PUBLIC COMMENT

HAMPSHIRE COUNTRY CLUB PLANNED RESIDENTAIL DEVELOPMENT **DECEMBER 2017 DEIS -SUBMITTED VIA EMAIL**

ADDITIONAL COMMENTS

Subject: Referral File No. MMV 18-001 - Hampshire Country Club

Betty-Ann Sherer IMG_3446.jpg

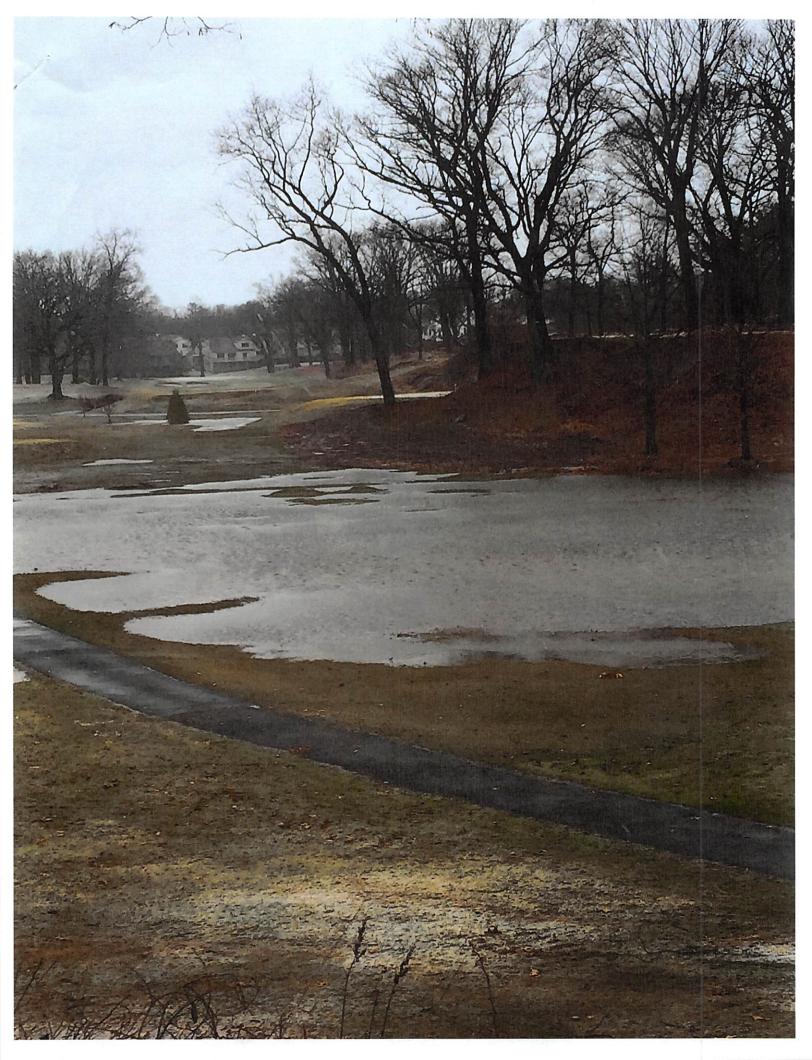
Please share this with the Planning Board. It is a photo taken this morning after only a few hours of rain. The water is deep and will result in homeowners being stranded on the golf course were homes built there. I am strongly against any development in this fragile location.
